RAI 03.07.02-29, Revision 1**QUESTION:**

RAI from Section 3.7 Audit, October 2010

REVISED RESPONSE:

Figure 03.07.02-29.91: Comparison of 5% damped Spectra at 1 ft Below Ground Surface (SHAKE2000 116 Layer Validation Problem 3)

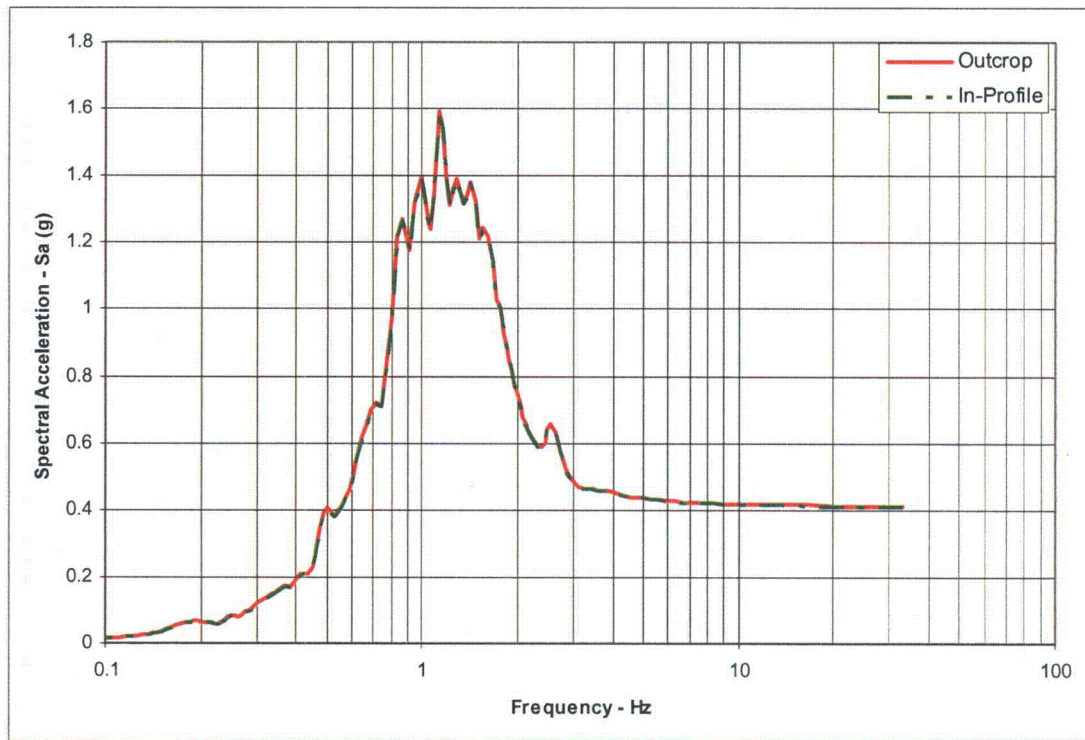
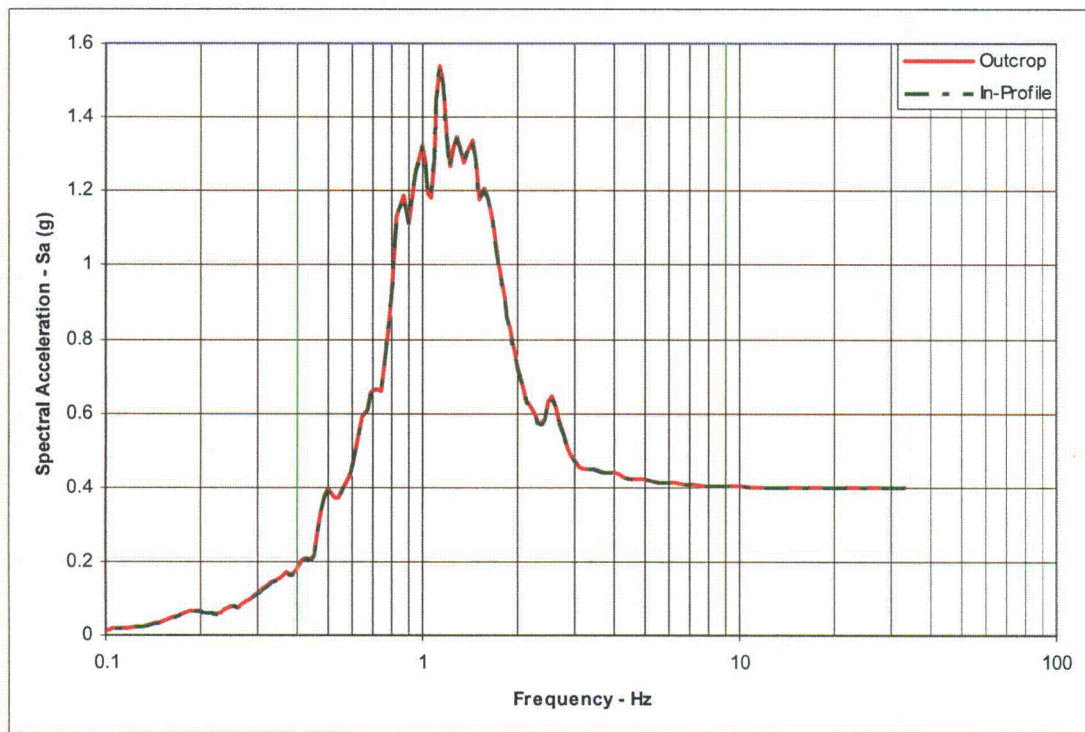
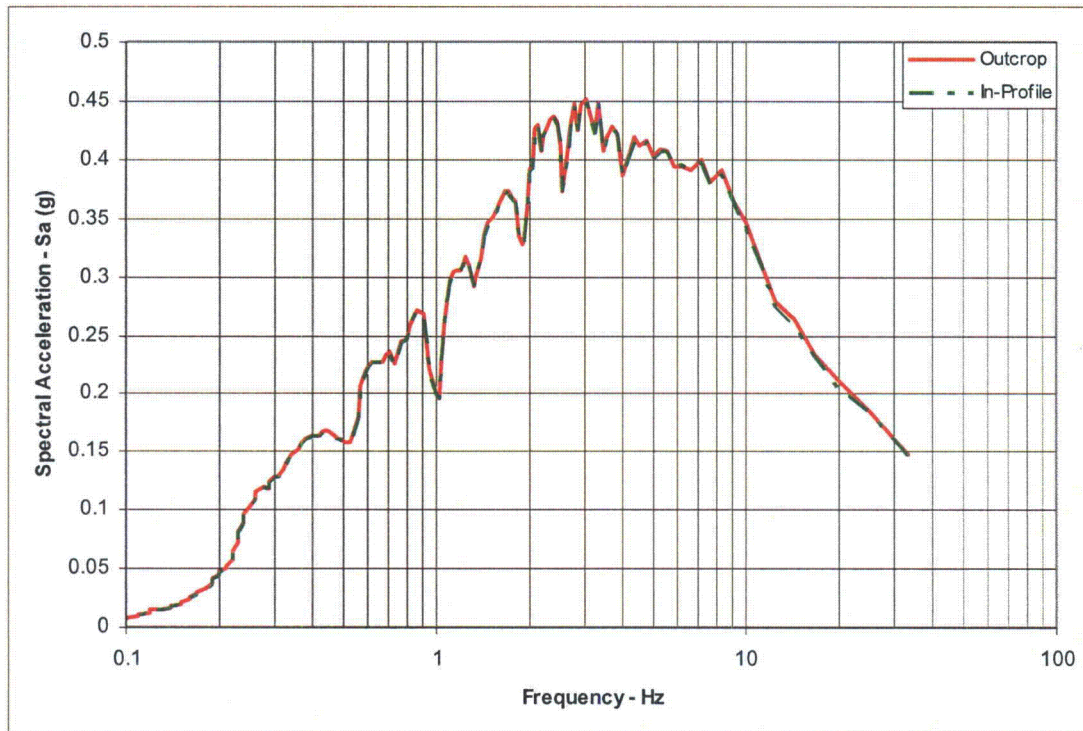
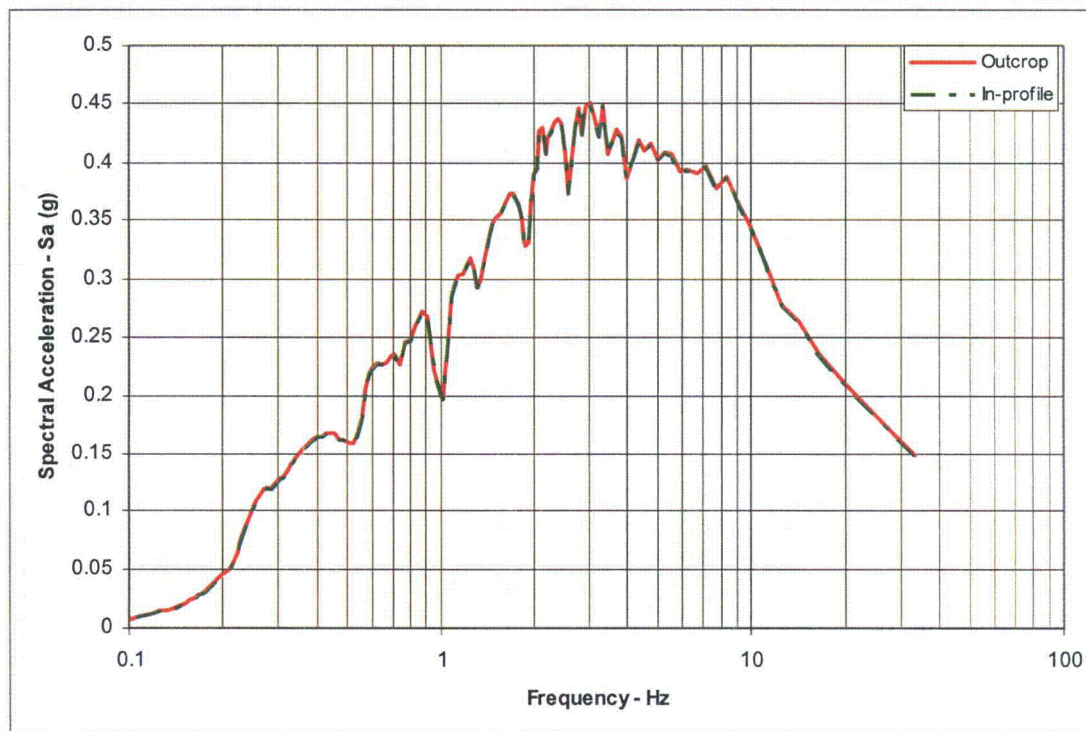
As such, the applicant is requested to supplement the SAP2000 V&V with additional test problems to address the items discussed above. The staff needs this information to be able to conclude in the SER that the use of SAP2000 in STP applications will not adversely affect calculation of seismic forces and moments and the evaluation of SSI effects for Category I structures.

the frequency content of input motion). For such a case the in-profile and outcrop motions at 1 foot depth should be the same. Figure 03.07.02-29.91 shows the comparison between the in-profile and outcrop 5% damped spectra at 1 foot below the ground surface. The two spectra are same (lay over on each other). Thus the option of the program for in-profile motion applied at the base of the soil profile and resulting outcrop motion at the ground surface is validated for large number of soil layers, up to 116 layers.
